# UNITED STATES PATENT AND TRADEMARK OFFICE

APPLICATION NO.	FILING DATE	FIRST NAMED INVENTOR	ATTORNEY DOCKET NO.	CONFIRMATION NO.
10/758,697	01/14/2004	Homer Eaton	ROMINC.004A	4972

<b>Office Action Summary</b>	<b>Application No.</b>	<b>Applicant(s)</b>	
	10/758,697	EATON, HOMER	
	<b>Examiner</b>	<b>Art Unit</b>	
	John P. Fitzgerald	2856

Slocum

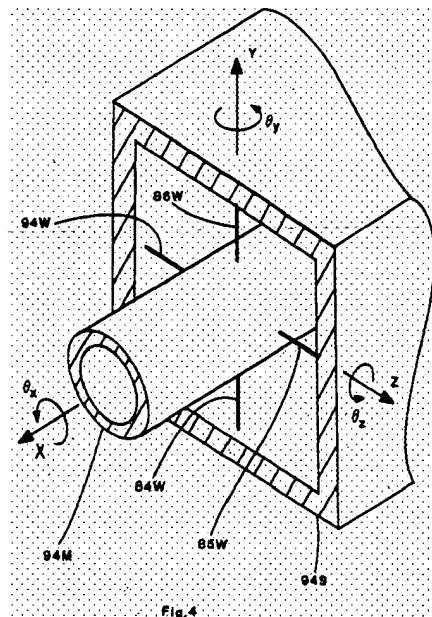
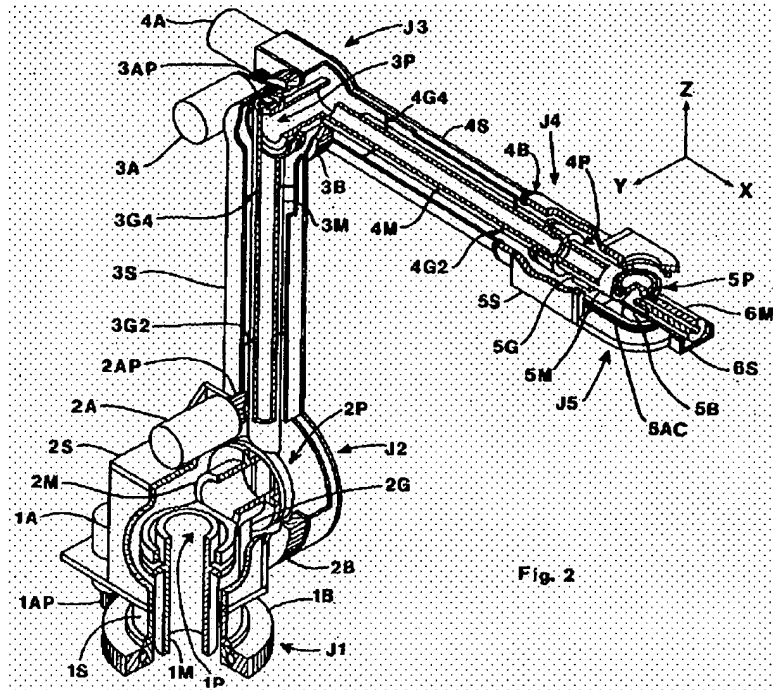
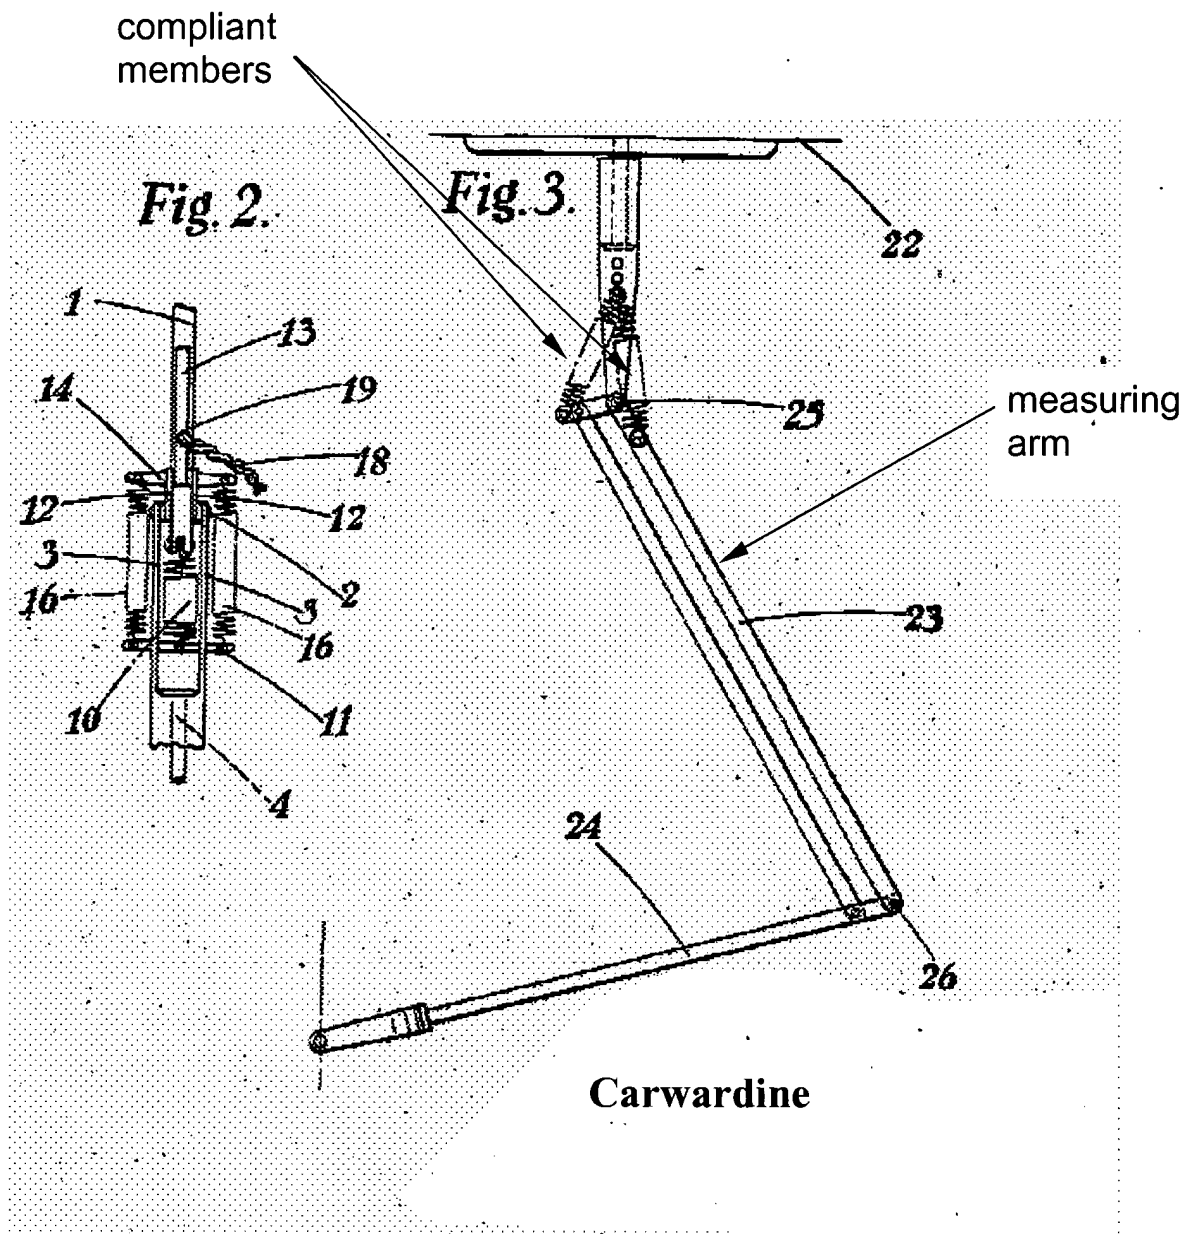
5. Claims 1, 6-15, 21-24, 31, 73 and 74 are rejected under 35 U.S.C. § 102(b) as being anticipated by US 4,676,002 to Slocum. Slocum teaches a positioning system (Figs. 1-20) and method for positioning an articulated measuring arm having an articulated supporting arm (1S, 2S, 3S, 4S, 5S and 6S) comprising of plurality of jointly interconnected support arm segments moveable about a plurality of axes; a plurality of compliant members (12W, 22W, 32W, 42W, 52W 62W, 84W, 85W, 94W) (see Figs. 3 and 4 below) positioned on the supporting arm; and an articulated measuring arm (1M, 2M, 3M, 4M, 5M and 6M) comprising a plurality of jointly interconnected measuring arm segments capable of a plurality of degrees of freed of movement and supported by the compliant members wherein the compliant members provide a yielding characteristic (i.e. made of a deformable material, as recited in claim 13) as well as a constrained range of alignment (as recited in claim 23) between the articulated supporting arm and the articulated measuring arm allowing for a degree of angular offset between the support arm and the measuring arm segments (Slocum: col. 10, lines 15 to col. 11, line 7) (as recited in claims 1, 10, 11, 73 and 74) as well as positioning and supporting the measuring arm segments with the support segments (as recited in claims 9, 73 and 74); wherein the supporting arm and the measuring arm are co-axially aligned such that the movement of the supporting arm effectuates movement of the measuring arm (as recited

in claims 6 & 7); wherein the support arm segments are shaped to partially contain the measuring arm segments (as recited in claim 8); wherein the compliant members can be chosen from magnetic levitation, air bearings (i.e. gas-filled chamber, as recited in claim 15), ball bearings, wire supports (i.e. metal/spring material, as recited in claim 14) and wherein a controller is configured to direct the positioning of the supporting arm (Slocum: Fig. 18). As to claims 12, 21, 22, 24, 73 and 74, the reduction of mechanical stress (i.e. load sharing/reduction/transfer, thermal isolation (an air gap provides thermal isolation) and physical perturbations/vibrations are inherent features of the compliant members and, as such, the compliant members disclosed by Slocum clearly meet these 'physical' limitations and will function accordingly.

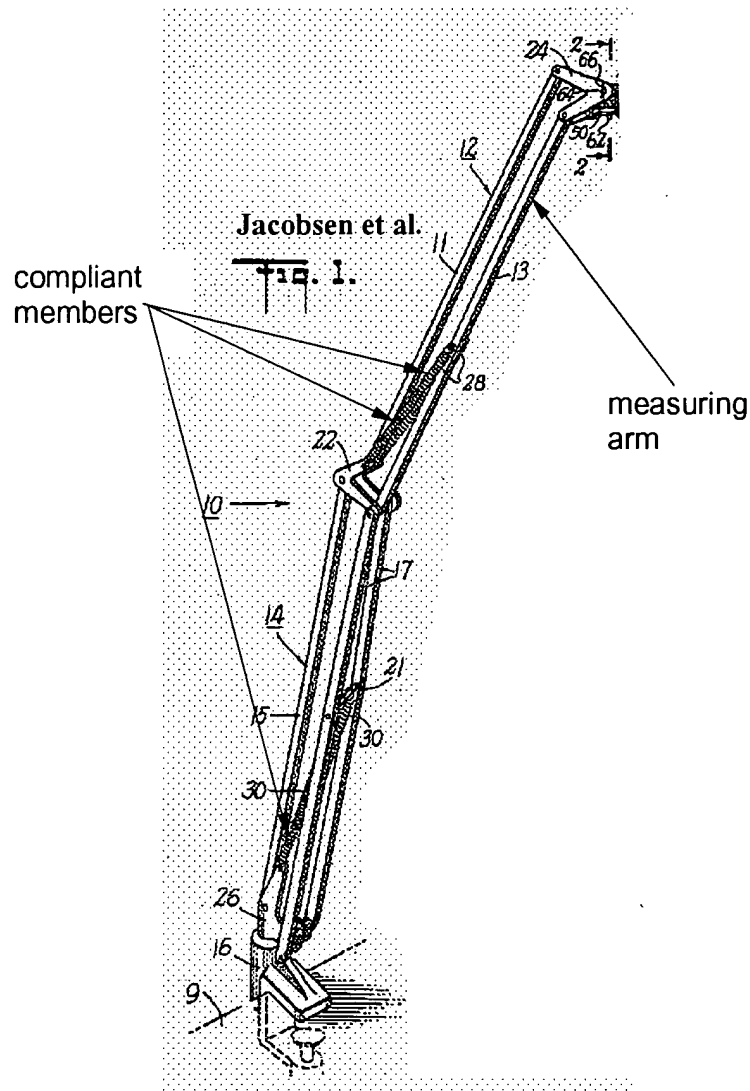
6. Claim 73 is rejected under 35 U.S.C. § 102(b) as being anticipated by US 2,076,446 to Carwardine. Carwardine discloses a method and apparatus for positioning an articulated measuring arm (23) (see Fig. 3 below) including supporting the arm at a plurality of locations with compliant members (10, 16) to reduce mechanical stress on the arm (i.e. forces balanced and steady positioning of the arm).

7. Claim 73 is rejected under 35 U.S.C. § 102(b) as being anticipated by US 2,787,434 to Jacobsen. Jacobsen discloses a method and apparatus for positioning an articulated measuring arm (13) (see Fig. 1 below) including supporting the arm at a plurality of locations with compliant members (30, 26) to reduce mechanical stress on the arm (i.e. forces balanced and steady positioning of the arm).

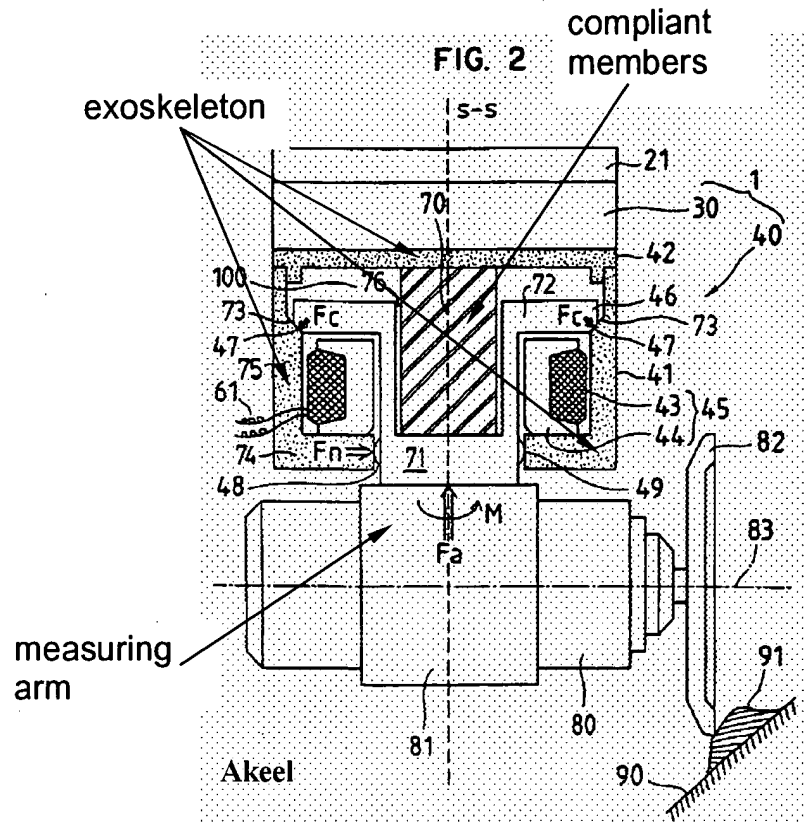
10. Claim 74 is rejected under 35 U.S.C. § 103(a) as being unpatentable over US 5,796,229 to Akeel. Akeel discloses a method and apparatus for damping external perturbations (i.e. reduction in vibrations and increased damping) encountered by an articulated measuring arm (71) (see Fig. 2 below) including supporting the arm at a plurality of locations with compliant member (70) that position at least a portion of the articulated the arm within an exoskeletal structure. Akeel discloses the claimed invention except for a plurality (i.e. multiple) elastic elements. It would have been obvious to one having ordinary skill in the art at the time the invention was made to employ multiple elastic elements, essentially splitting the compliant member (70) into a plurality of members, since it has been held that mere duplication of the essential working parts of a device involves only routine skill in the art. *St. Regis Paper Co. v. Bemis Co.*, 193 USPQ 8 (CA7 1977).
